DESCRIPTION OF PROPOSED CHANGES NPF-10-161 AND NPF-15-161
AND SAFETY ANALYSIS

This is a request to revise Sections 3/4.1.1.2 and Bases - Reactivity Control Systems - Shutdown Margin - Tavg Less Than or Equal to 200°F, 3.1.2.2 - Reactivity Control Systems - Flow Paths - Operating, 3.1.2.4 - Reactivity Control Systems - Charging Pumps - Operating, 3.1.2.6 - Reactivity Control Systems - Boric Acid Makeup Pumps - Operating, 3.1.2.8 - Reactivity Control Systems - Borated Water Sources - Operating, and 3/4.1.2 Bases - Boration Systems of the Technical Specifications for San Onofre Nuclear Generating Station Units 2 and 3.

DESCRIPTION OF PROPOSED CHANGE NPF-10-163 AND SAFETY ANALYSIS

This is a request to revise Sections 3.1.2.7 Borated Water Source-Shutdown, 3.1.2.8 Borated Water Sources - Operating, and Bases 3/4.1.2 Boration Systems of the Technical Specifications for San Onofre Nuclear Generating Station Unit 2.

Figure 3.1-1

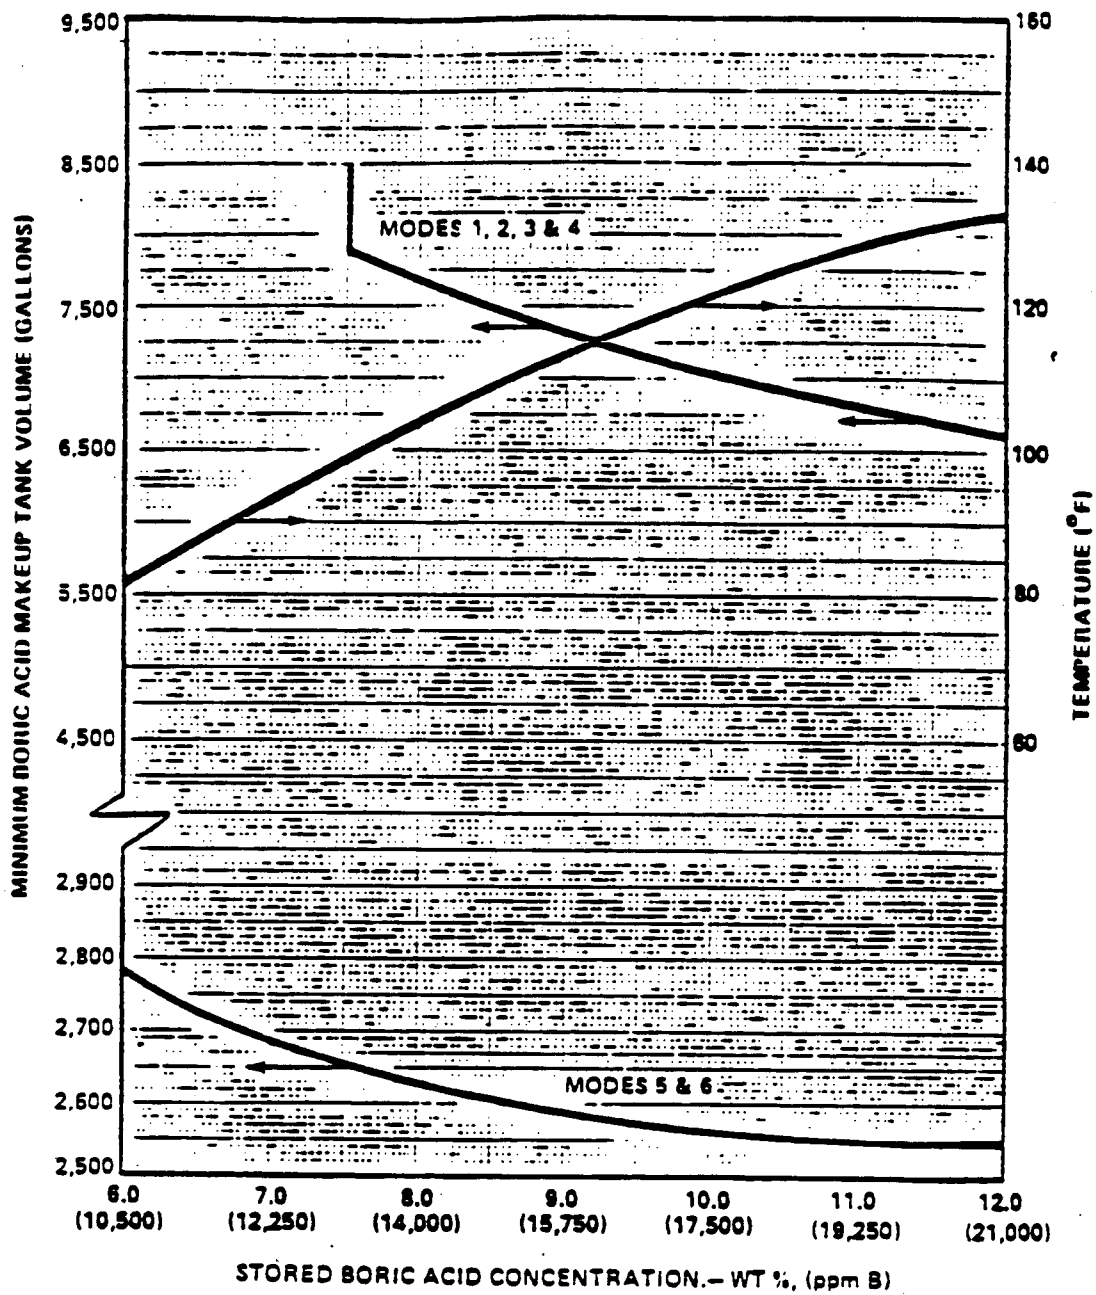
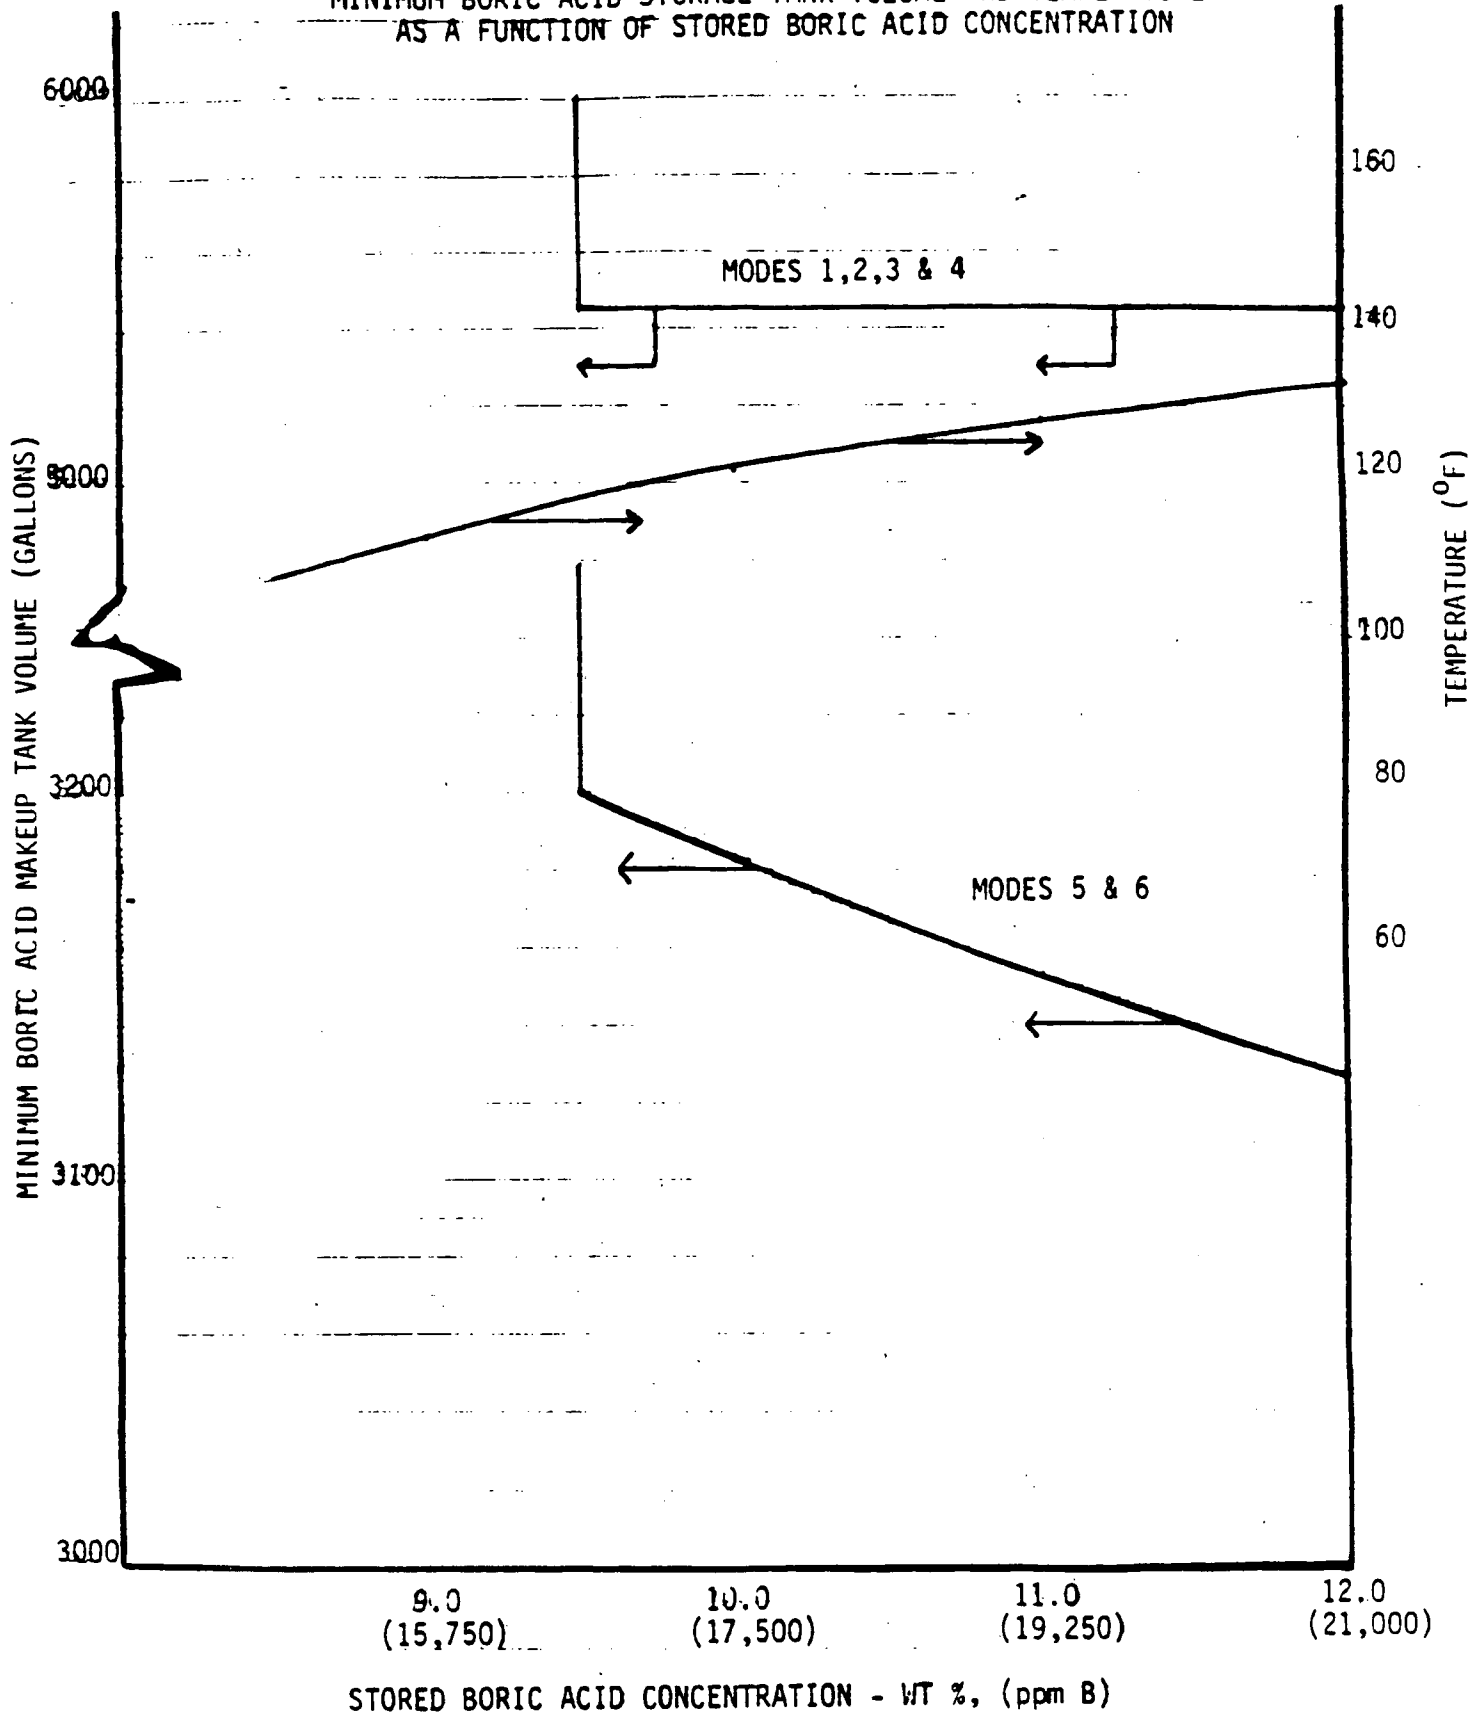
Core performance analyses of the Cycle 2 reactor fuel management design show that the boron concentration required to 1) maintain the required SHUTDOWN MARGIN after xenon decay and cooldown to 200°F, and 2) satisfy Criterion 26, has increased due to the differences in core design and core performance characteristics from Cycle 1. As a consequence, the minimum borated volume in the refueling water storage tanks and the minimum boric acid makeup tank volume (Figure 3.1-1) must be revised for Cycle 2 operation in order to meet the Limiting Conditions for Operation on Shutdown Margin. The minimum volume required in the boric acid makeup tank and refueling water storage tank in Modes 5 and 6 has been increased due to the increased Mode 5 Shutdown Margin required for Cycle 2 operation. In addition, the Modes 1 through 4 boric acid makeup tank volume requirement has been decreased in order to facilitate plant operation while providing the required Shutdown Margin. For Cycle 1 operation, borated water from the boric acid storage tank was used during plant shutdown to provide makeup for RCS shrinkage. Makeup for RCS shrinkage during Cycle 2 will be provided from the refueling water storage tank.

Therefore, Sections 3.1.2.8 and B3/4.1.2 have been revised to specify the boric acid storage tank volume/concentration and the refueling water storage tank volume required for negative reactivity control consistent with the requirements of Cycle 2 operation.
